SUBJECT: Requests approval for use of relief request number 36
 concerning ASME Section Category B-F, to address surface
 examinations of identified Class 1 nozzle-to-safe end welds
 associated with reactor pressure vessel.

Subject: Inservice Inspection Program ASME Section XI
Required Examinations
Third 10-Year Interval
Request for Relief Regarding Request No. 36
R.E. Ginna Nuclear Power Plant
Docket No. 50/244

Rochester Gas and Electric Corporation
Ginna Station
Docket No. 50/244
Third 10-Year Interval
Request for Relief No. 36
Reactor Pressure Vessel Nozzle-to-Safe End Butt Weld Surface
Examination Limitations

Attachment 2

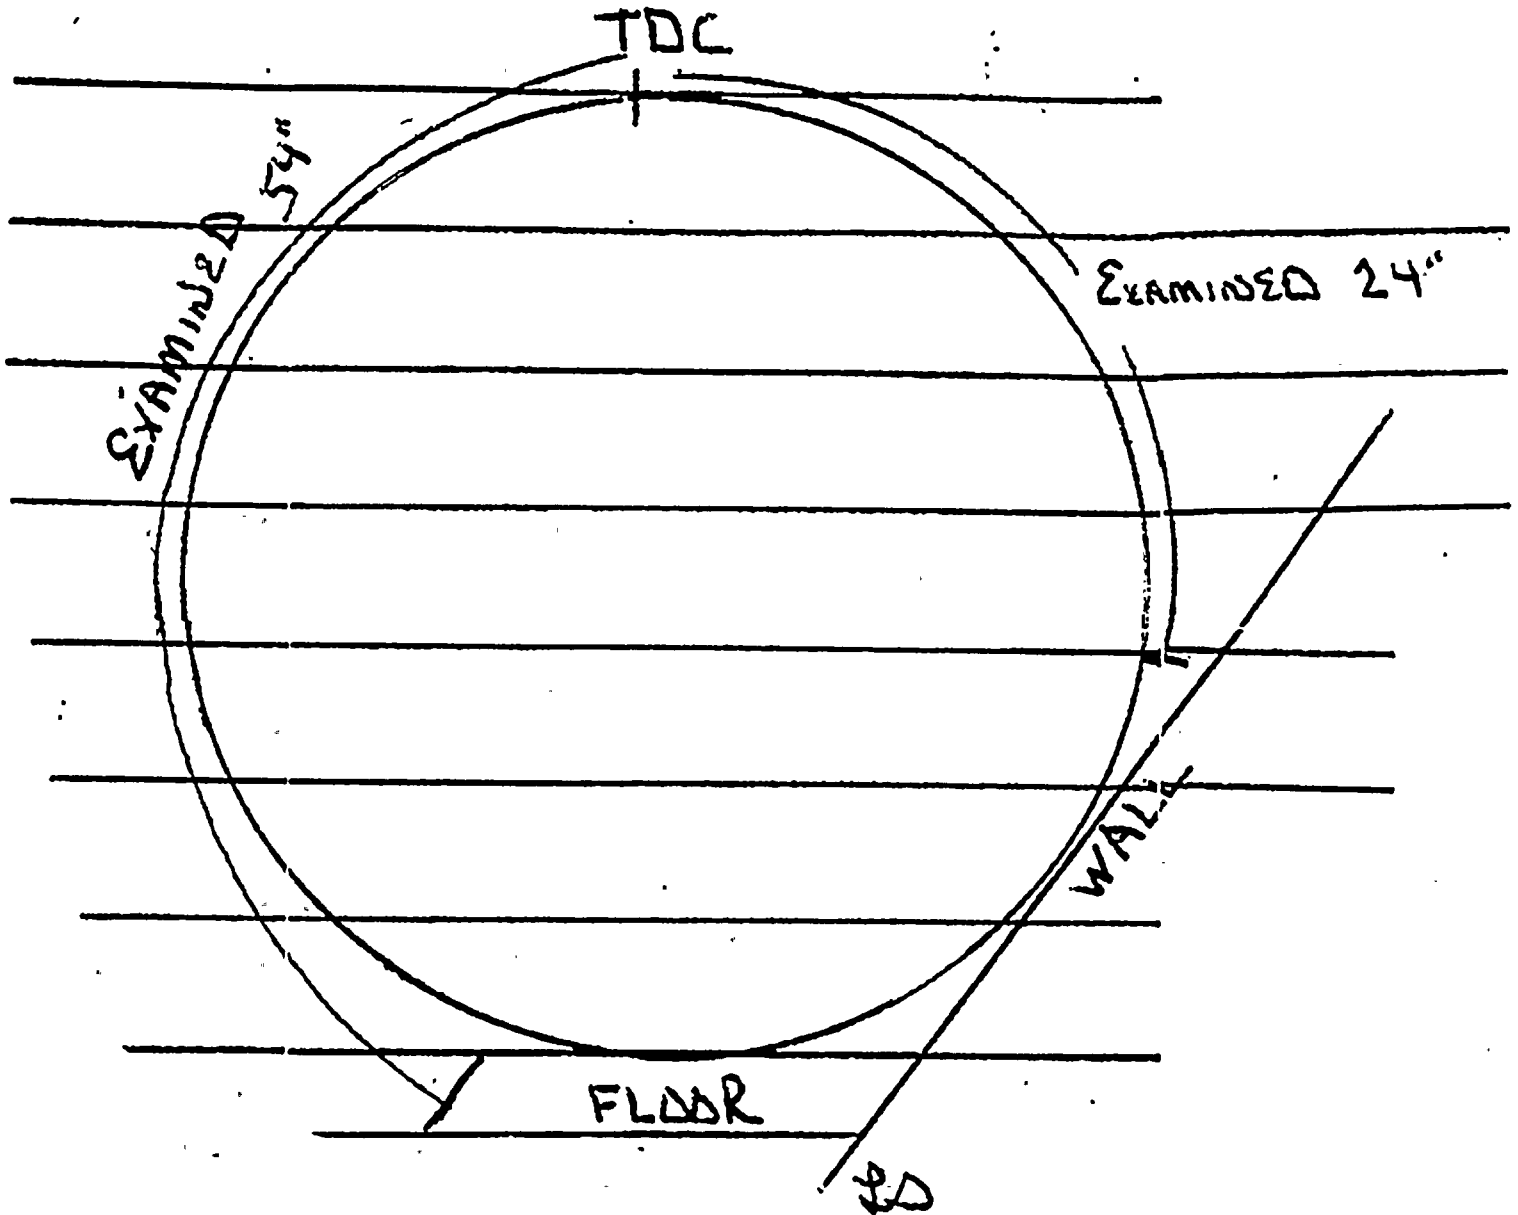
The first four (4) welds of this Relief Request are located in a "Sandbox" configuration. Within the "Sandbox", the welds are against the floor and one wall. The angled wall is joined to the floor and is against the weld. The surface examination of these welds is limited due to Original Construction Code interferences of the floor and wall of the "Sandbox". The "Sandboxes" would have to be redesigned to enable the welds to be inspected to obtain Code required coverage for the surface examinations. The attached sketch (Attachment 2) shows a representative weld with similar interferences.

EXAMINATION AREA LIMITATION (IF NONE, SO STATE):

Due to Configuration of Floor and Wall NO EXAM IN AREA NOT IDENTIFIED IN DRAWING

R.E. Ginna Nuclear Power Plant proposes that the surface examination coverage identified for the first four (4) welds above be acceptable in fulfilling the Code required examination coverage. The actual physical configuration of the "Sandboxes" is not conducive in obtaining the requirements specified within Code Case N-460 for acceptable coverage. Volumetric examination of these welds is performed from the inside of the Vessel, and will be performed during the 1999 outage.
